# E C O L O G I C A L R E V I E W

**Four-Mile Canal Terracing and Sediment Trapping**  
CWPPRA Priority Project List 9  
State No. TV-18

October 9, 2003

Jean L. W. Cowan  
And  
Kyle F. Balkum  
Restoration Technology Section  
Coastal Restoration Division  
Louisiana Department of Natural Resources

Figure 2: Layout of terrace fields in Little White Lake and Little Vermilion Bay (HNTB 2003).

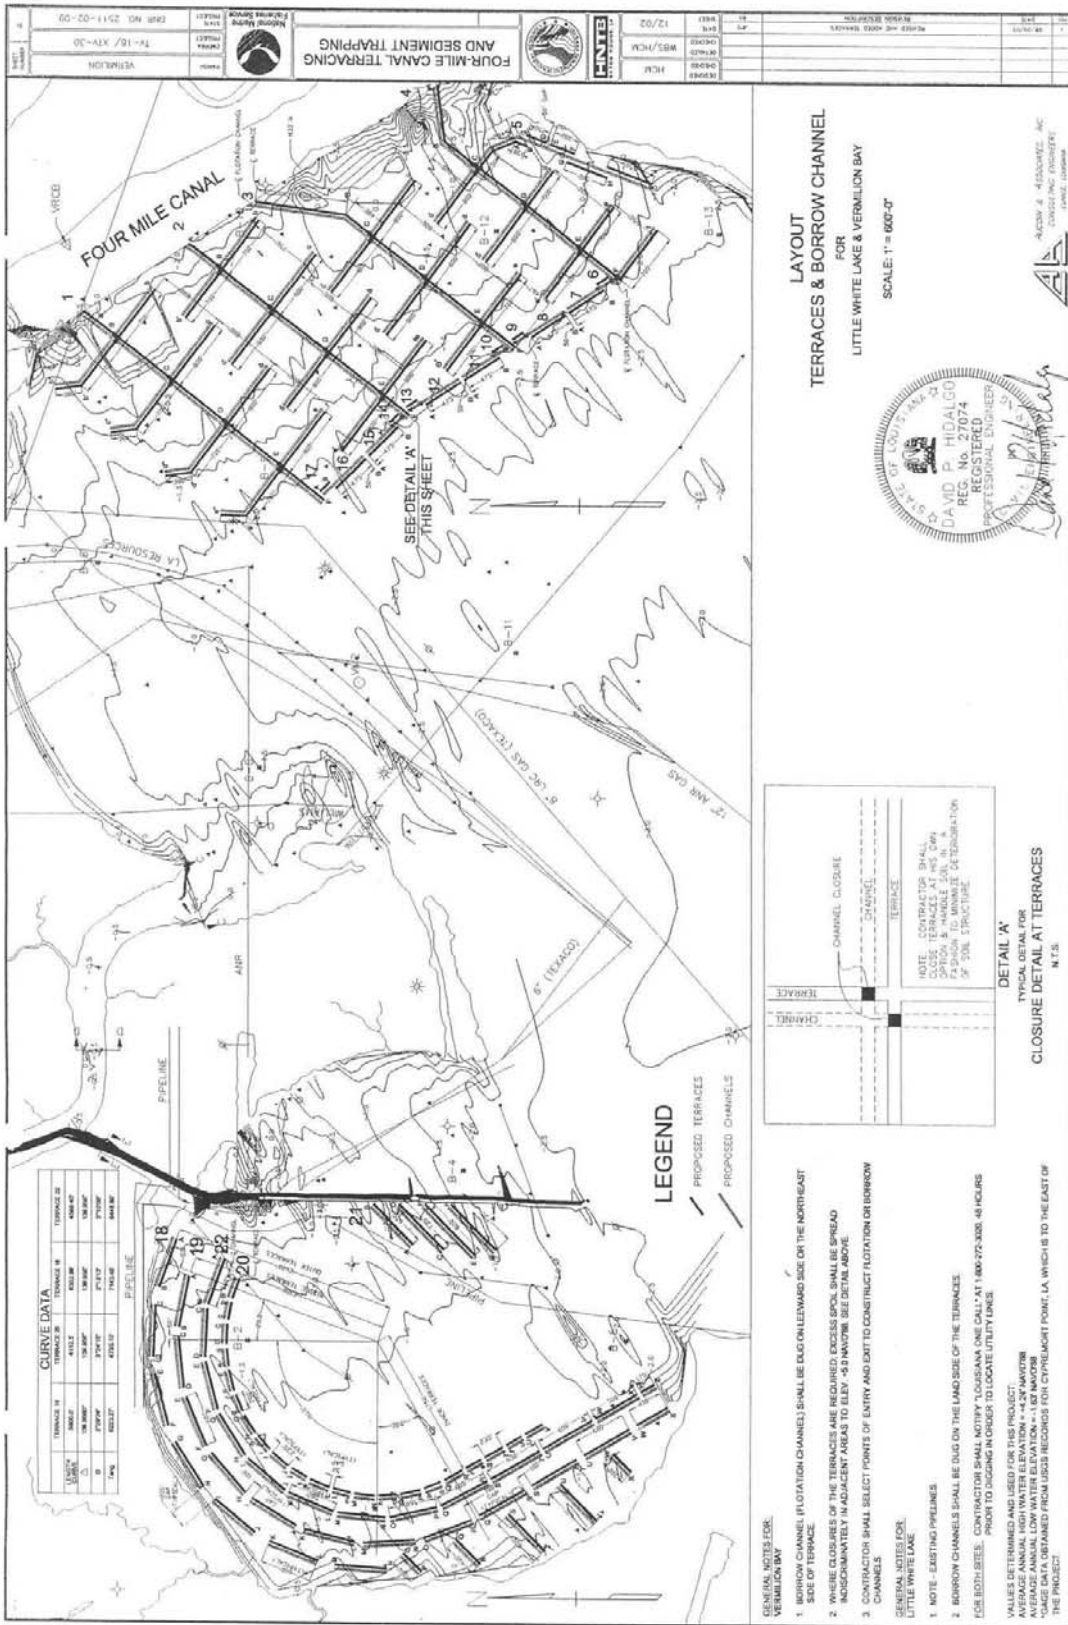
Four rows of terraces will be constructed in Little White Lake, roughly following the shoreline contour (Figure 2). This configuration was chosen to avoid problems with a pipeline that runs through the middle of the lake and because of land rights issues. The rows will be staggered so that the openings between terraces in any one row are located approximately in the middle of the terraces in the adjacent row, in order to minimize the wave energy reaching the currently existing shoreline (Talbot 1995). It is expected that this terrace configuration will also trap sediment resuspended from the lake-proper during storm events and, in doing so, provide episodic opportunities for subaerial land growth. In order to facilitate trapping of sediment being delivered to the area from the Vermilion River, four additional terraces will be constructed along the left descending side of the channel that connects Little White Lake to the river (Figure 2). The terraces in Little White Lake will be 28,150 feet in total, and will immediately create 31 acres of emergent land.

Terraces in Little Vermilion Bay will be constructed in an open "fish-net" design (Figure 2). This configuration is expected to operate as a baffle system which will slow the flow of water entering from Four Mile Canal, thereby allowing sediment to fall out of suspension within the terrace field. The primary terraces will be constructed in a NW-SE orientation, in order to provide the existing shoreline maximum protection from south-westerly winds to which the area is currently vulnerable. Existing land protects this area from south-easterly and northerly winds, but not to south-westerly winds that may dominate in the summer months. Further, the terrace configuration will reduce saltwater intrusion into Four Mile Canal, thereby protecting existing brackish and intermediate marsh along the Canal from further degradation. This design will also minimize the

fetch distance within the terrace field which will reduce wind-wave sediment resuspension, increase water clarity, and provide the opportunity for SAV establishment. Finally, maximizing the marsh edge within the terrace field will benefit the goal of increasing fisheries utilization in the area. The terraces in Little Vermilion Bay will be 42,400 feet in total, and will immediately create 52 acres of emergent land.

Figure 3: Comparison of soil characteristics among proposed terracing project sites.

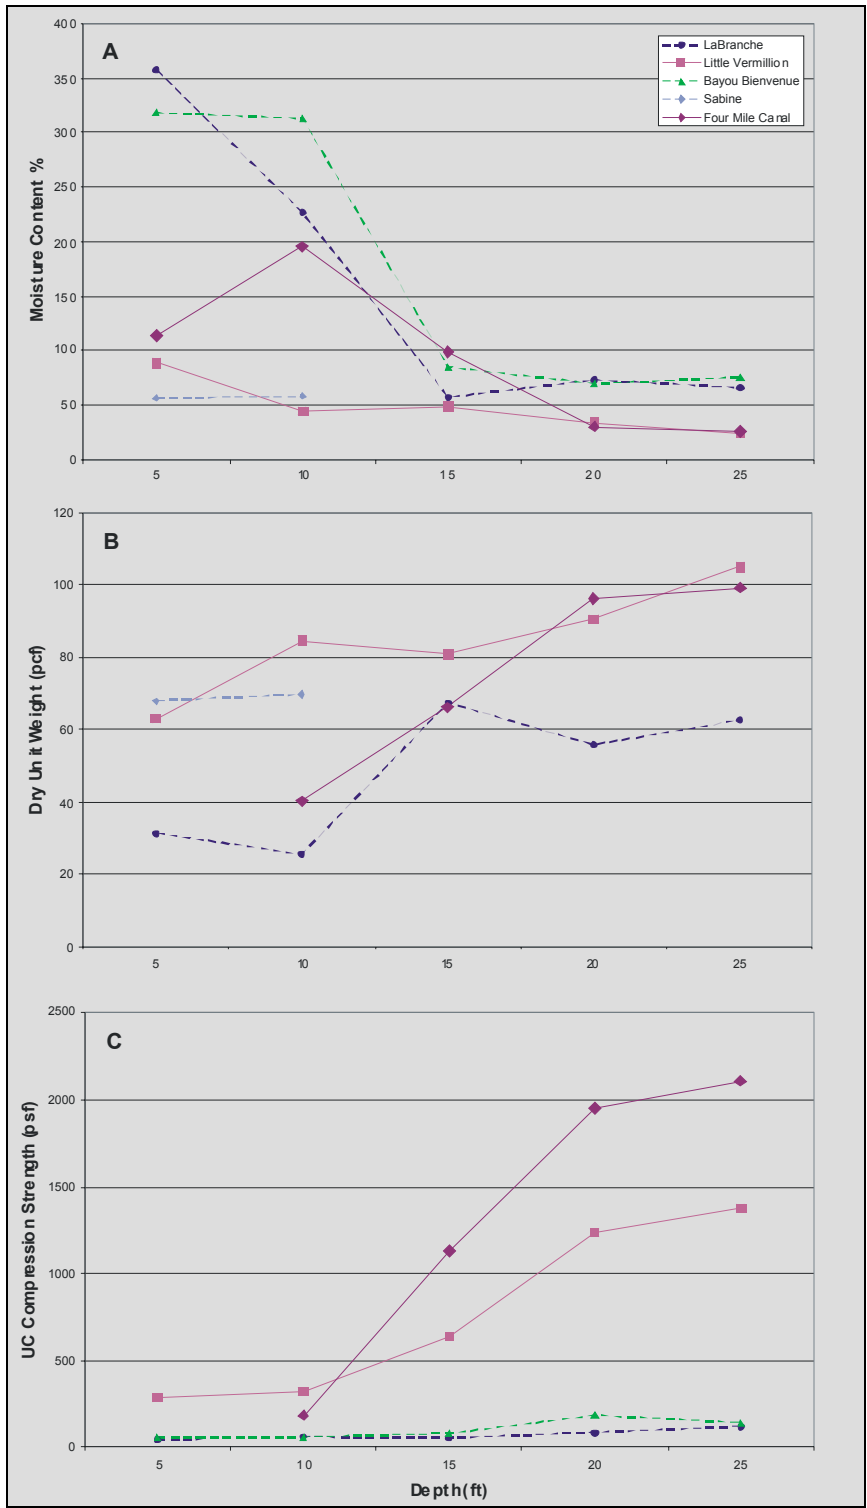
The stratigraphy of the TV-12 project area is similar to that of the proposed TV-18 site. Soil characteristics were compared graphically between the proposed TV-18 project, the constructed TV-12 project, and two proposed terracing projects (PO-25 and PO-28) that were not constructed (Figure 3). The Bayou Bienvenue Terracing (PO-25) project was not constructed because of poor soil conditions which, in the relatively deep water of the project area, compromised the potential success of the project. Additionally, there were several anticipated logistical problems associated with construction. In addition to the similarly poor soil conditions, the La Branche Terracing (PO-28) project was not built because of land-rights issues. Compression strengths are poor for the two projects that were not constructed, but are similar between Little Vermilion and Four Mile Canal. The moisture content and dry unit weight data for the top 15 feet of soils at the proposed TV-18 site are less desirable than found at the Little Vermilion site.

The engineering analysis performed for the proposed TV-18 project concluded that terraces, if built as proposed, would cause compression of native soils by 15-25% under the weight of the berms, and that the crest will settle due to consolidation within the fill. As a result, future addition of height may be required (HNTB Corporation 2002). It was further recommended that consideration be given to constructing the project in two stages, where the initial height of the

terraces would be 1-3 feet above average high water. One to two years later, a second stage of construction could commence to reach the desired crest elevation.
